**ADDENDUM NO. 1**  
**2025 ASPHALT OVERLAY PROJECT**  
**PROJECT #12525**

**ATTENTION ALL BIDDERS AND PLANHOLDERS:** You are hereby notified that the Bid and Contract Documents are amended as follows:

2025 ASPHALT OVERLAY

SITE SPECIFIC DATA			
PROJECT NUMBER		12525	
PROJECT NAME		2025 ASPHALT OVERLAY	
PROJECT LOCATION		20TH PL S	
PIPE DATA	I.E.	MATERIAL	DIAMETER
INLET PIPE 1	319.63	HDPE	15"
INLET PIPE 2	N/A	N/A	N/A
OUTLET PIPE	319.13	CONC PIPE	15"
RIM ELEVATION	327.50		
NOTES: SLOPED RISER MAY BE REQUIRED

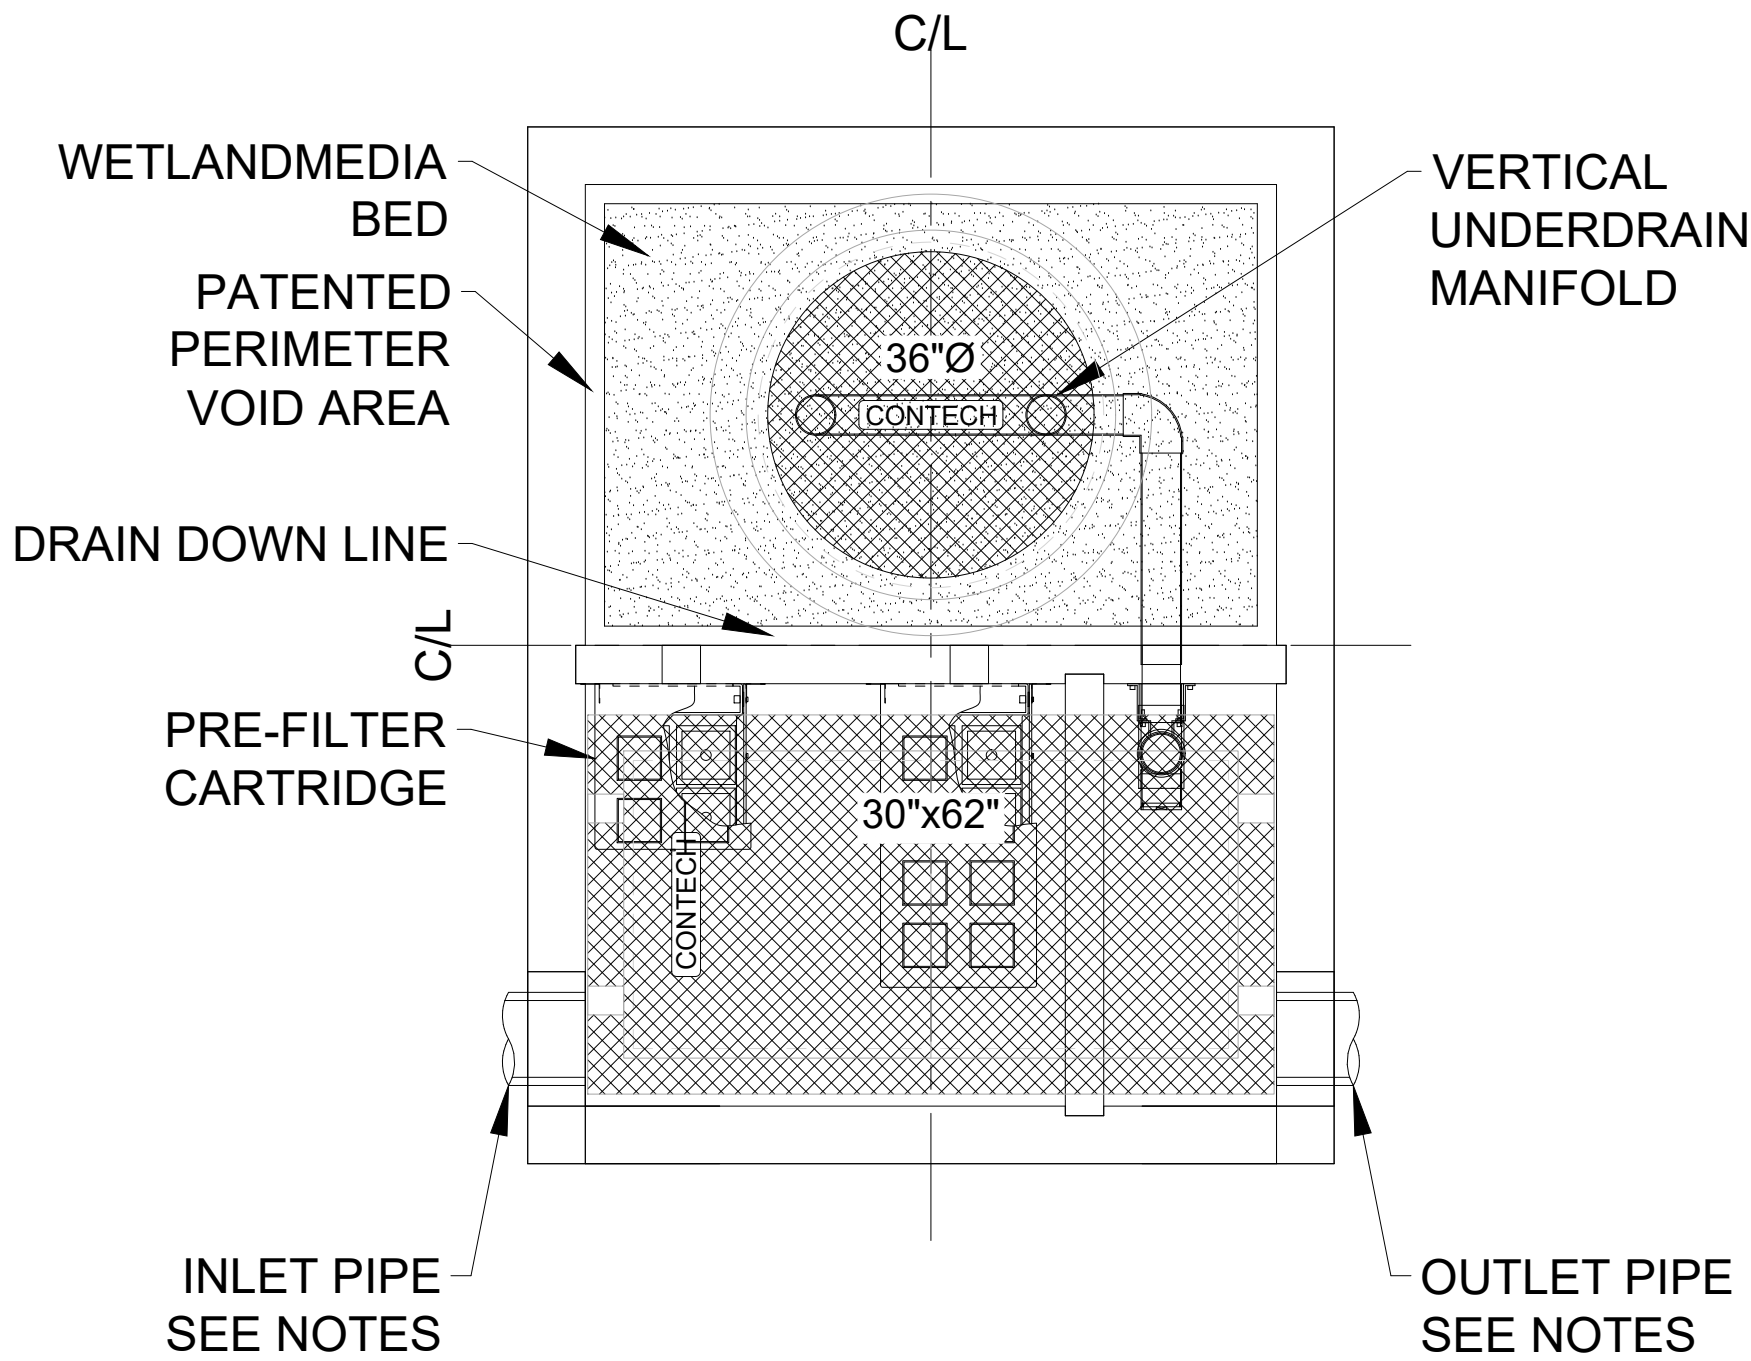
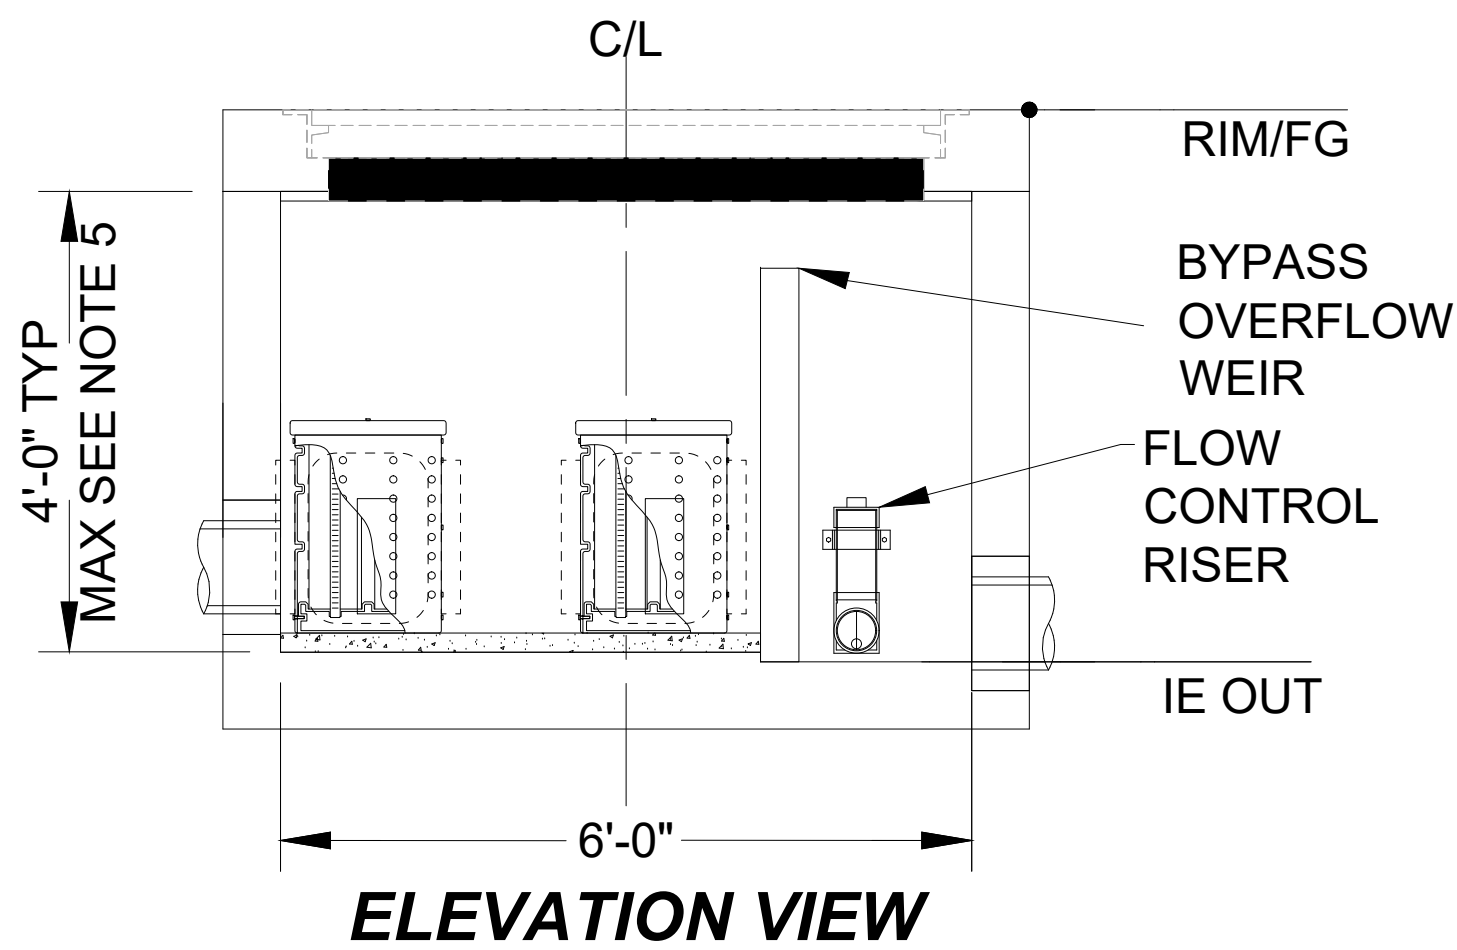
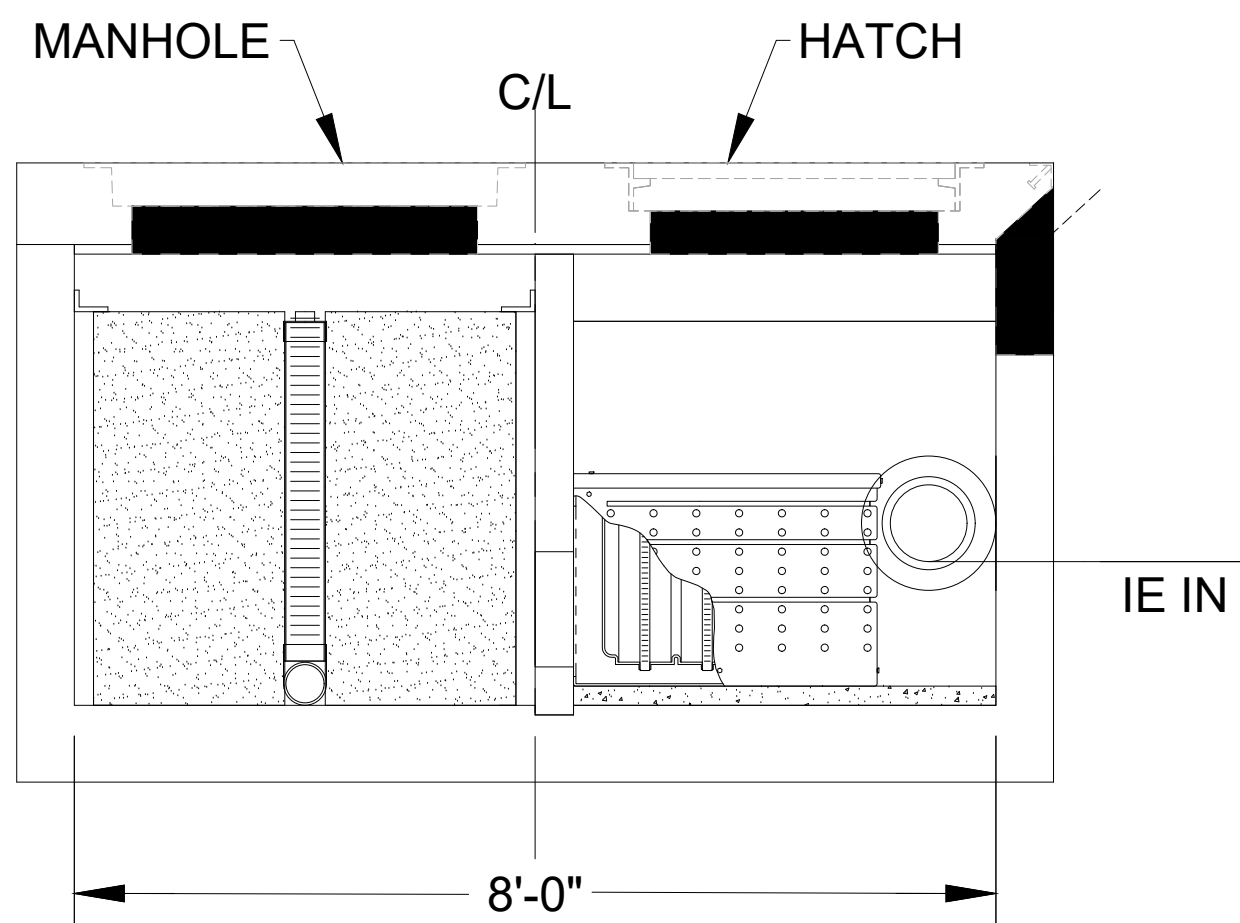
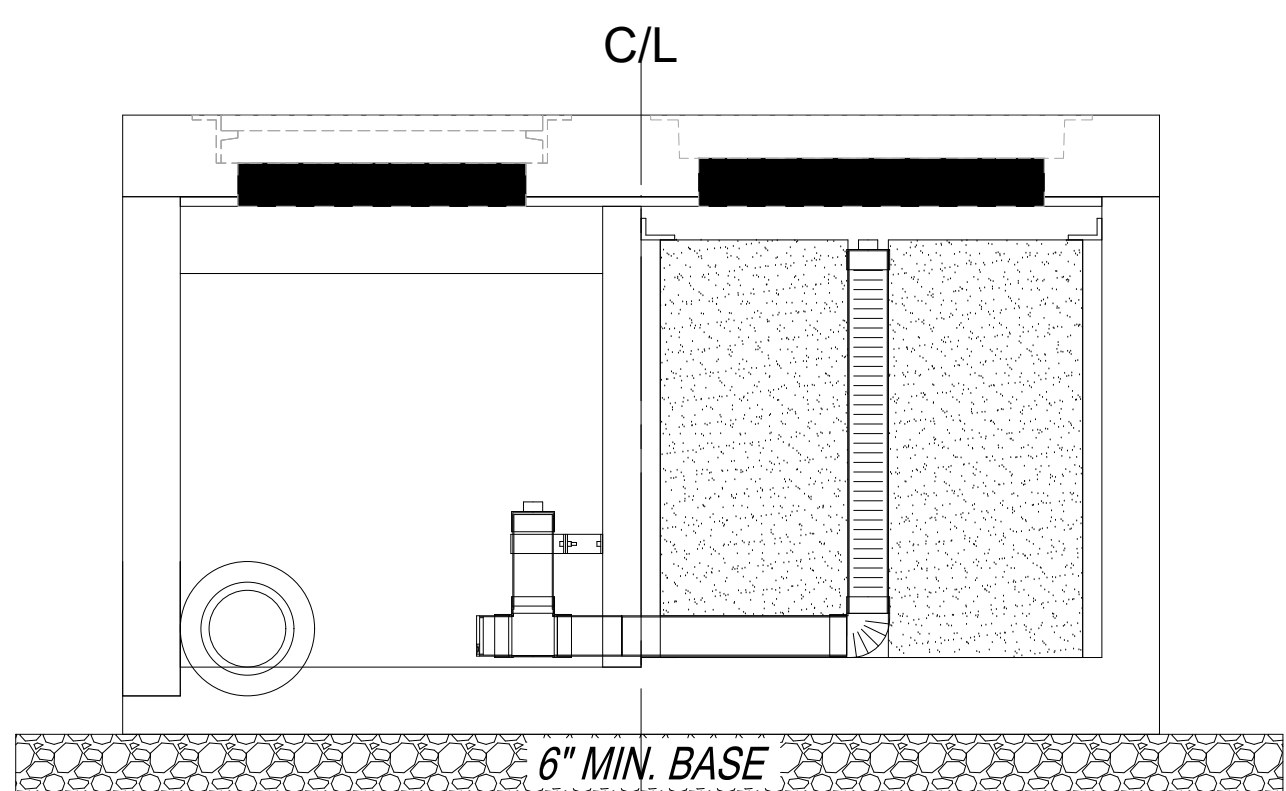
**(5) Sheet 67 of 125 Plan Set:**

- “Site Specific Data” table for Modular Wetland updated.

SHT. 73

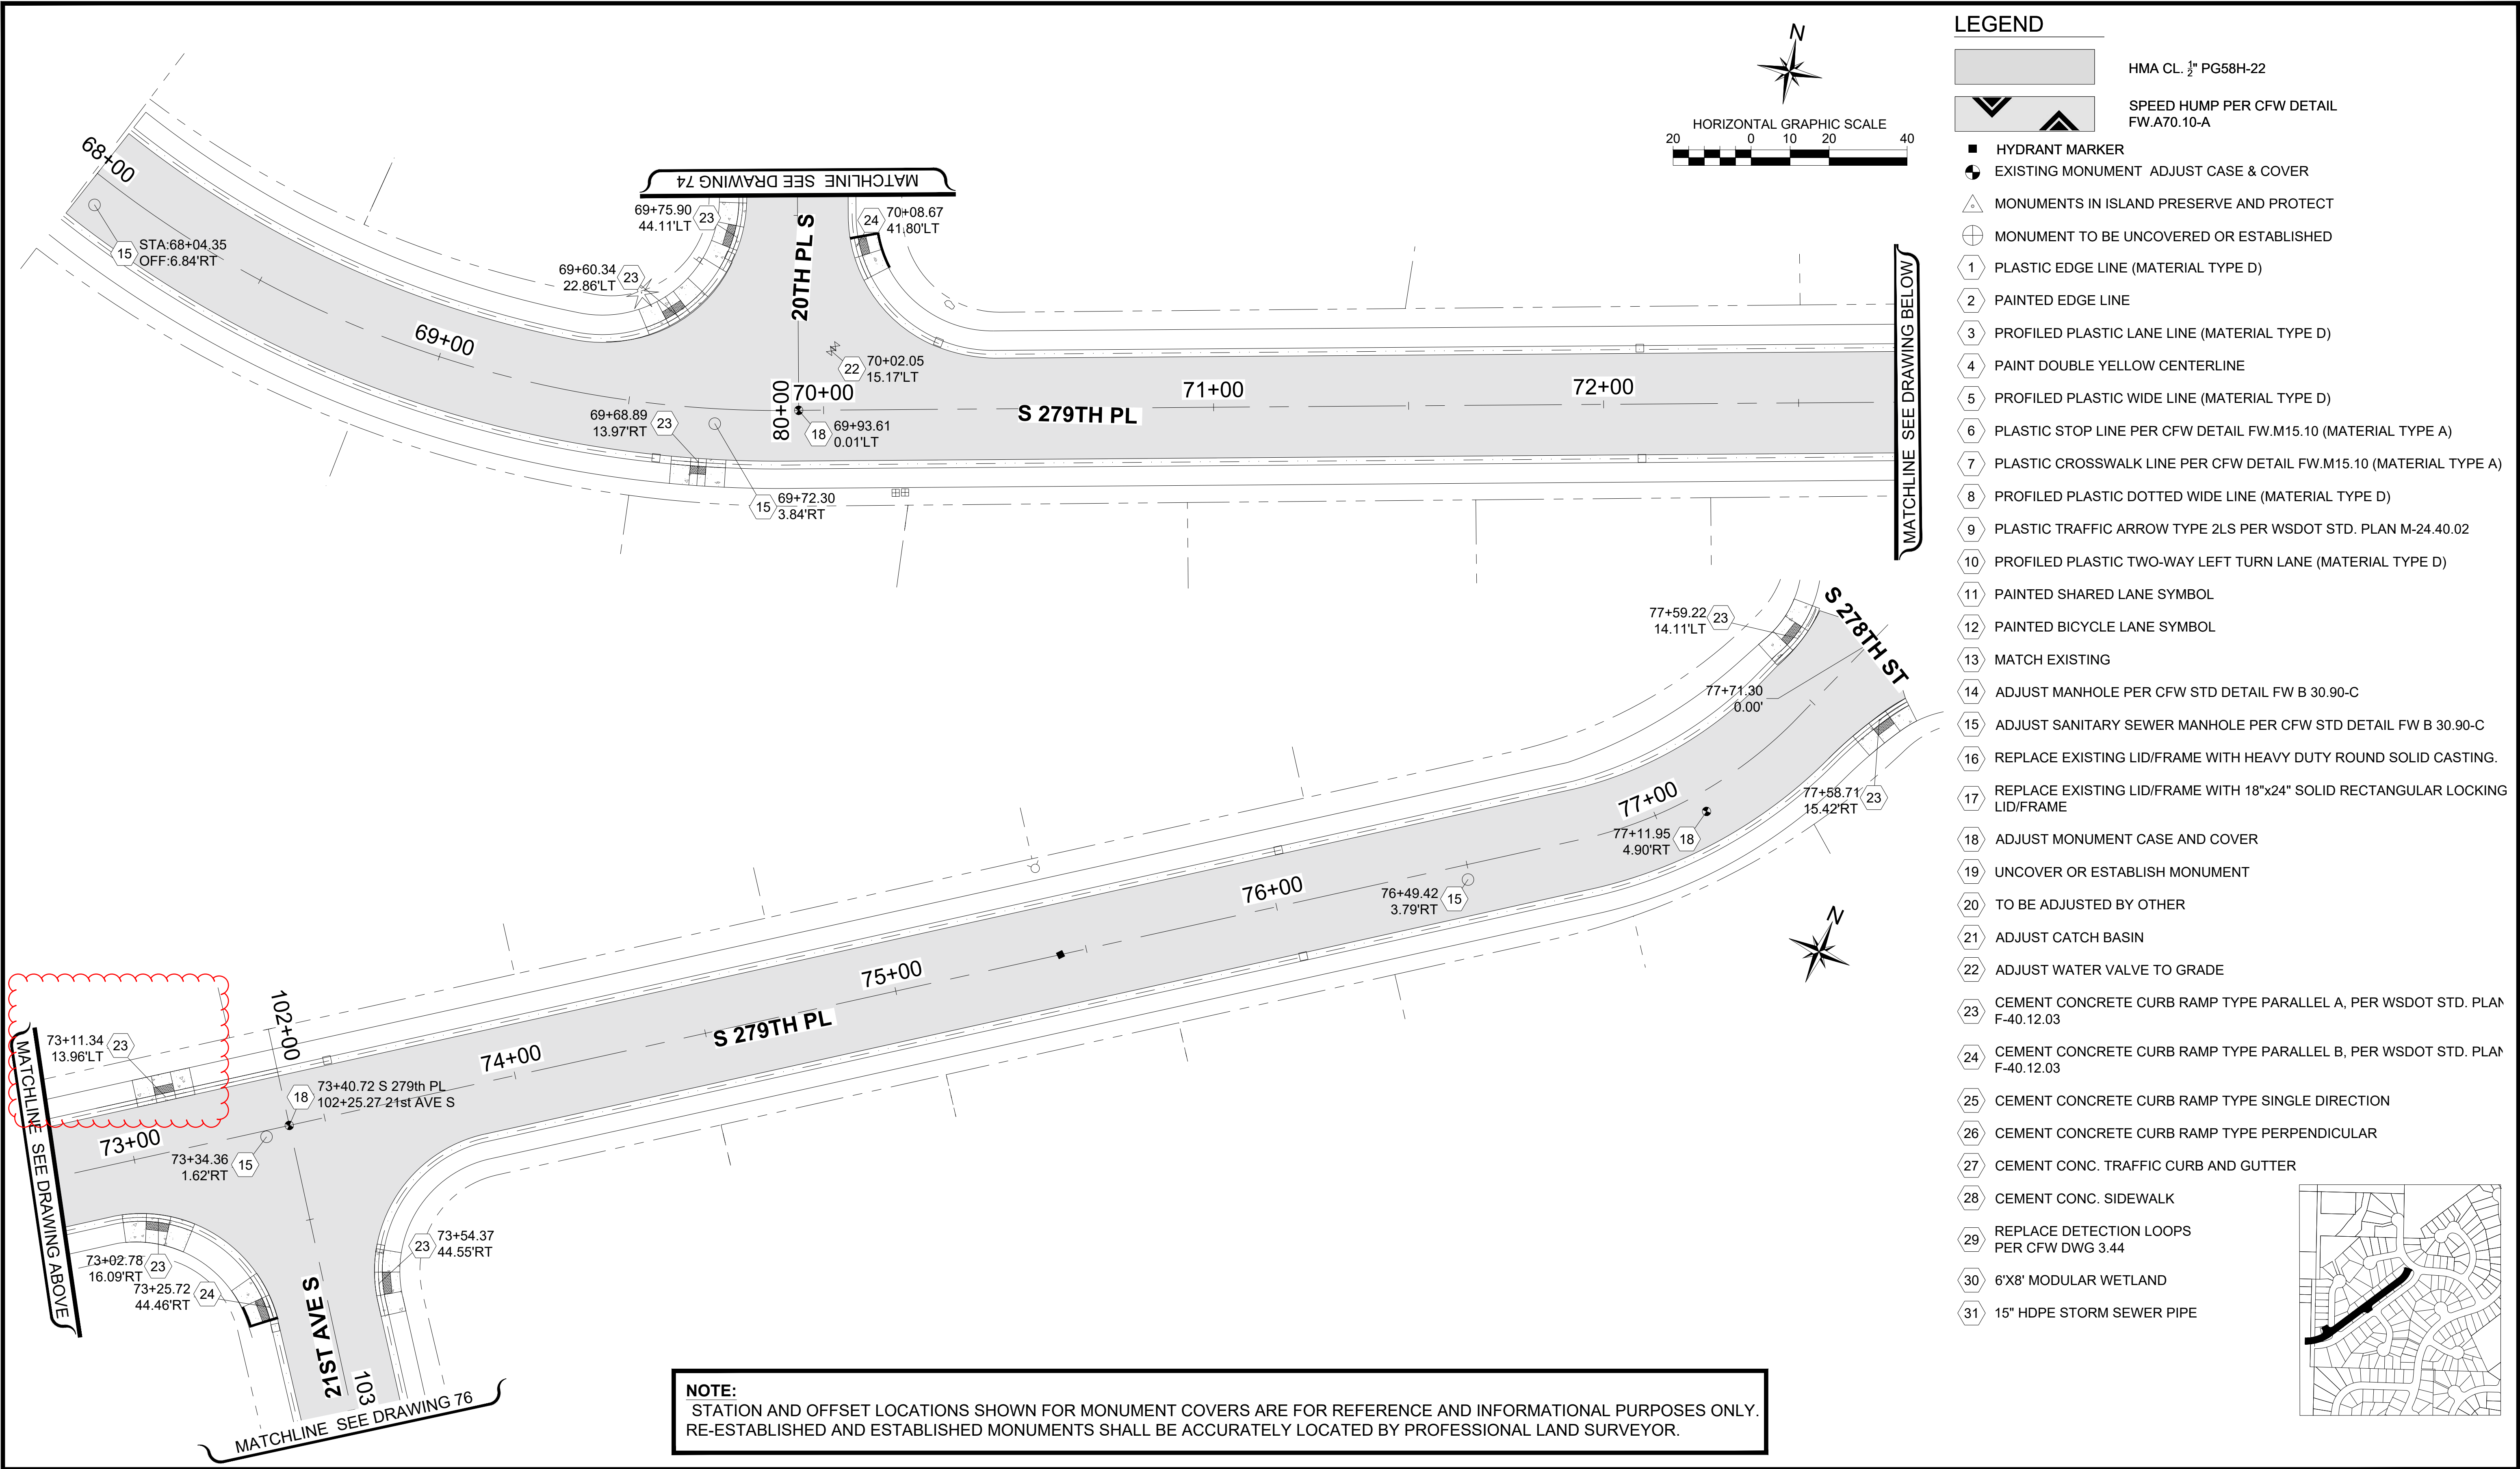
**(7) Sheet 73 of 125 Plan Set:**

- Fixed callout for Ramp
